SUBJECT: CERTIFICATE AMENDMENT REQUEST - PORTSMOUTH GASEOUS DIFFUSION
PLANT WITHDRAWAL STATIONS STANDBY OPERATIONAL MODE (TAC NO.
L32006)

CERTIFICATE HOLDER: United States Enrichment Corporation
Portsmouth Gaseous Diffusion Plant
Portsmouth, Ohio

SUBJECT: COMPLIANCE EVALUATION REPORT: APPLICATION DATED
NOVEMBER 8, 1996, WITHDRAWAL STATIONS STANDBY
OPERATIONAL MODE

Figure 1 ERP and LAW UF₆ Flow Diagram

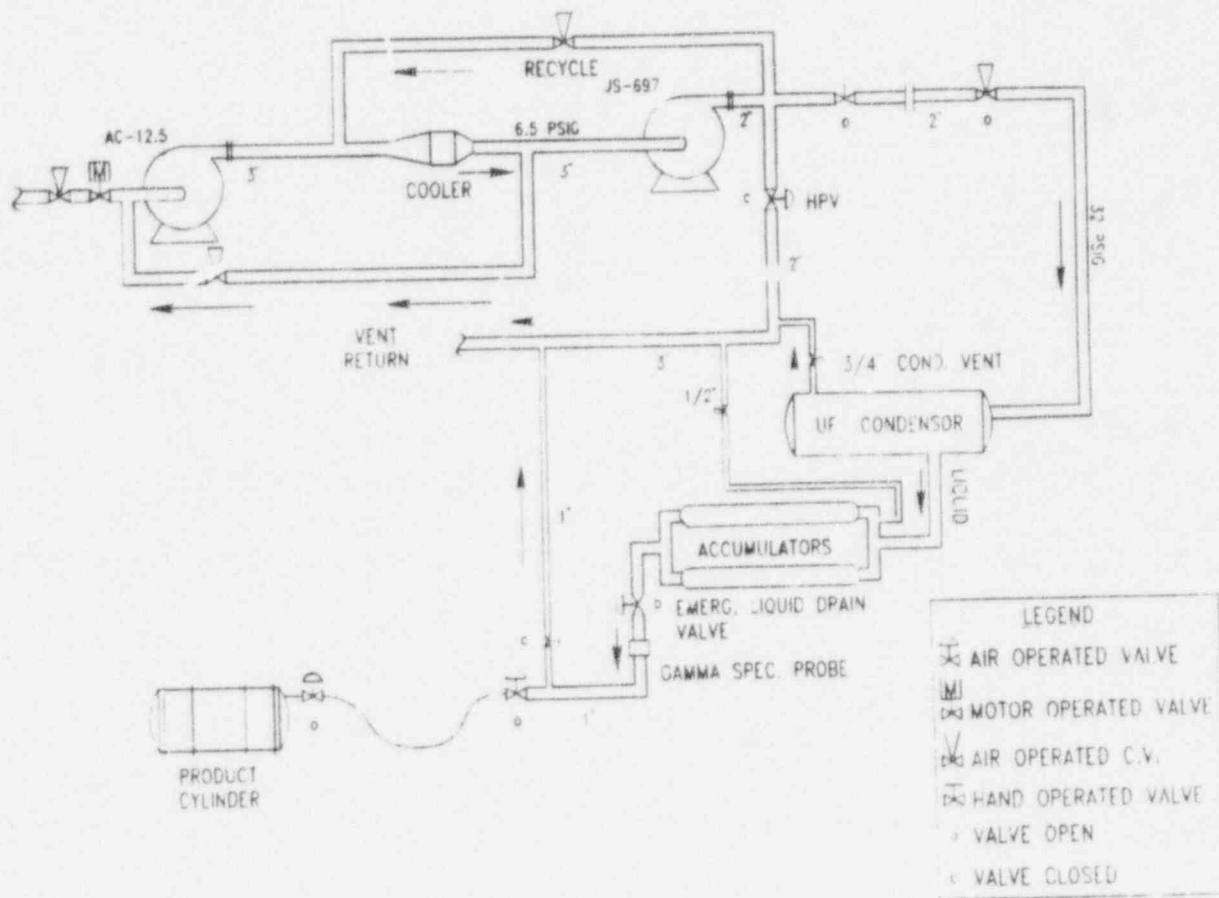
Each compression loop at ERP and LAW has a 2-inch line installed from the discharge of the second stage compressor to the vent return header. A 2-inch air-operated valve is installed in this line for the purpose of "manually" or "automatically" relieving high pressure back to the cascade from the loop, when necessary. Only remote "manual" venting is provided for the compression loop at the Tails Withdrawal Facility where the

The proposed change to TSR 2.5.1 permits evacuating UF_6 from the compression loop in the UF_6 withdrawal station to the cascade, which acts as a low pressure sink, in the Standby Operational Mode. This change will not result in significantly increasing the potential for unconfinement of UF_6 since it only involves venting of UF_6 from one portion of process piping which confines UF_6 in the Withdrawal Station to another portion of process piping which confines UF_6 in the enrichment cascade. In fact, venting the compression loop to the cascade may enhance safety by minimizing the potential for over pressurization of the UF_6 withdrawal loop with subsequent confinement rupture. Confinement of UF_6 within the cascade is primarily provided by maintaining the cell high-side (compressor discharge) gas pressure below 25 psia (TSR 2.2.3.13) and by appropriate quality assurance requirements to process gas piping and equipment (Safety Analysis Report Section 3.8.2.2). Confinement of UF_6 in the Withdrawal Station compression loop is primarily provided by maintaining UF_6 pressure below acceptable levels via the High Pressure Venting (HPV) system and by appropriate quality assurance requirements to process gas piping and equipment (Safety Analysis Report Sections 3.8.1.1.8, 3.8.1.2.8, 3.8.1.3.9, and 3.8.2.2). The HPV, which can be operated in automatic or manual mode at ERP and LAW and only in the manual mode at Tails, relieves to the cascade, any unusual pressure buildup in the Withdrawal Station compression loop.

- a. This amendment involves a valve that is internal to several valves even when the pigtail is not attached to the withdrawal manifold. These valves would be in the closed position. Therefore, several misvalving errors would be required to permit significant wet-air inleakage into the cascade through the compression loop vent valve.

Based on the information provided in this CER, the NRC staff approves and grants this amendment. Region III staff have no objection to this proposed action.

Figure 2 Tails Withdrawal UF_6 Flow Diagram

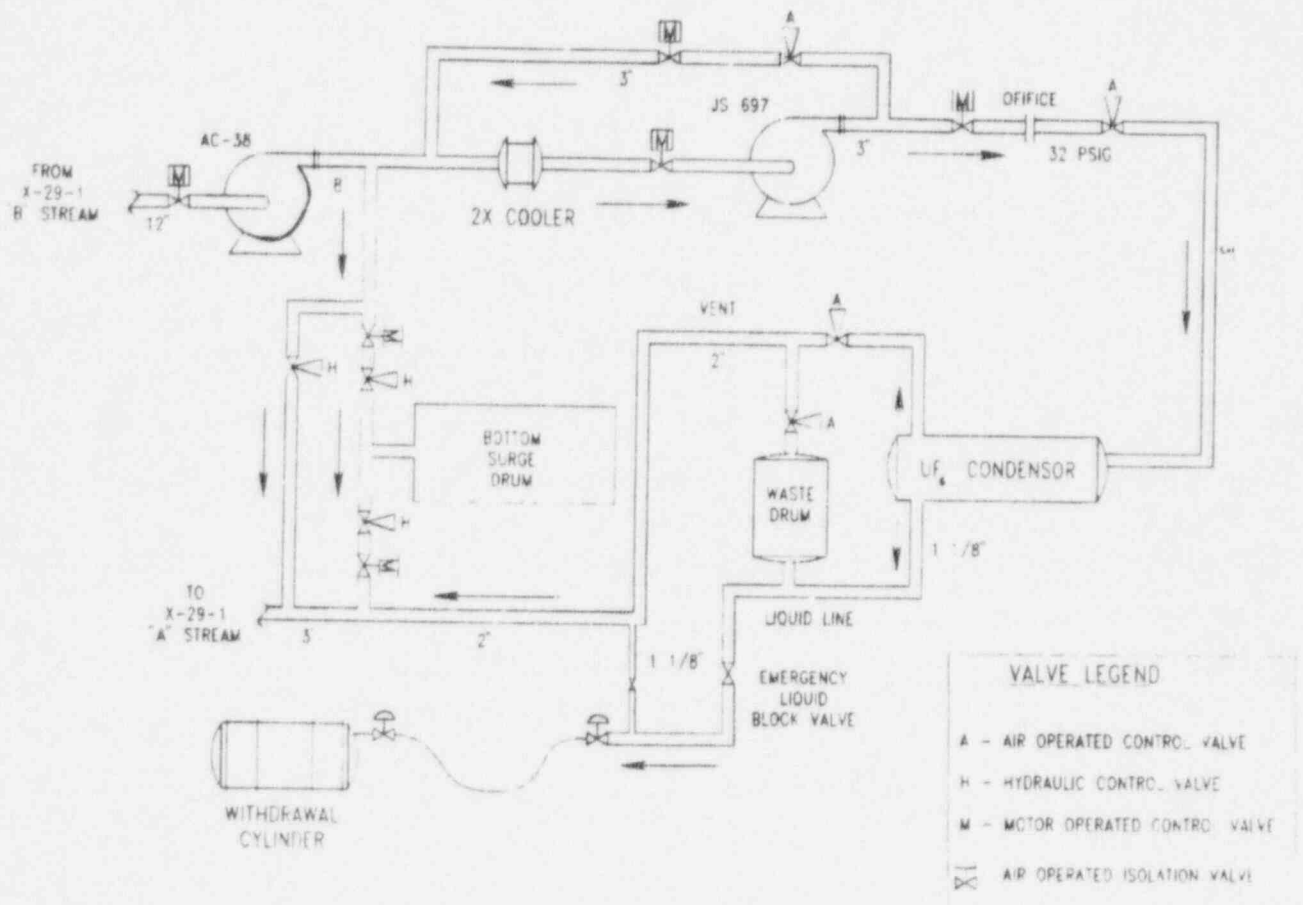
vent line is installed from the discharge of the first stage compressor to the vent return header. While the withdrawal loop is in a condition known as "station recycle," the vent path from the compression loop to the cascade may be opened to evacuate UF_6 from the compression loop. Under the current TSR Standby Operational mode definition, this compression loop evacuation scheme, which is a DOE authorized activity, would not be allowed, since it requires the vent valve(s) to be closed. Therefore, to continue routine UF_6 withdrawal operations at PORTS, USEC needs to have the Standby Operational Mode definition amended to allow the vent path from the compression loop to the cascade to be open or closed. It should be noted that this amendment does not involve three other vent pathways, i.e., from the condenser, accumulator, and the withdrawal manifold to the vent return header. These pathways will remain closed in the Standby Operational Mode.
